**HOME MAINTENANCE (Walk Behind 28")**

**Models Affected:** CC-600 (12ACW62R709, 12ACW62R710, 12ACW62R756).

**Part Affected:** 664-05085A / 964-05085A Grassbag Cub Cadet

**Subject:** Grassbag Replacement

**FIGURE 1**

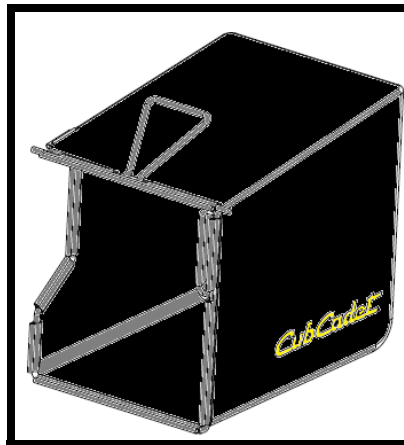
We have received reports from the field of grass clippings dropping/blowing out of the grassbag. A new updated grassbag is now available for mowers that experience this issue. The updated grassbag allows more air to flow to pass through the grassbag.

1. If a customer has a complaint of the grass clippings dropping/blowing out of the grassbag on one of the above listed Models Affected, order a new updated Cub Cadet grassbag **964-05085B** from your parts source.

**NOTE:** 964-05060B is an optional plain (no logo) new updated grassbag.

2. Install the new updated Cub Cadet grassbag on the mower.
